ALAMEDA COUNTY  
HEALTH CARE SERVICES

April 13, 2007

Subject: Fuel Leak Case No. RO0000085 and Geotracker Global ID T0600101487, Oakland Truck Stop, 8255 San Leandro Street, Oakland, CA 94621

Attachment: Historic Tide Data Plot for October 12, 2006

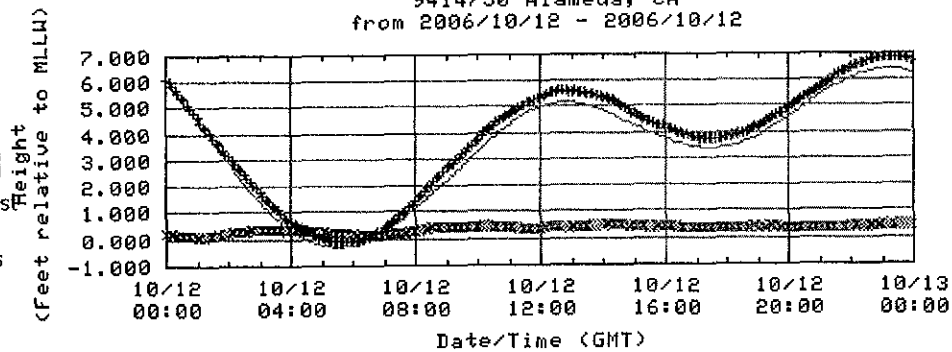
2. **Tidal Influence and Groundwater Flow Direction.** Based on water levels measured over a tidal cycle, the report concludes that tidal influence is at least partially responsible for the inconsistent groundwater flow direction and gradient that is observed at the site. The fluctuations observed over the 12-hour period of water level measurements ranged from a maximum of 0.05 to 0.2 feet depending upon the well. During quarterly monitoring events, water levels in adjacent wells typically differ by several tenths of a foot to more than a foot. Therefore, tidal influence does not appear to be the primary source of inconsistent water levels and hydraulic gradients measured at the site. We also question whether there is tidal influence at the site. The report indicates that high tide on October 12, 2006 was at 05:49 a.m. followed by low tide at 10:29 a.m. and then a second high tide on 04:12 p.m. Attached is plot of historic tide data from the National Oceanic and Atmospheric Administration for October 12, 2006, which shows low tide occurring at approximately 05:30 a.m. followed by a high tide at 12:42 p.m. Given the lack of response in the wells during the tidal cycle, no further investigation of tidal influence is needed. Although the hydraulic gradient is variable, the hydraulic gradient frequently indicates groundwater flow towards the creek that is located west and southwest of the site. The creek must be considered a potential receptor for groundwater contamination from the site.
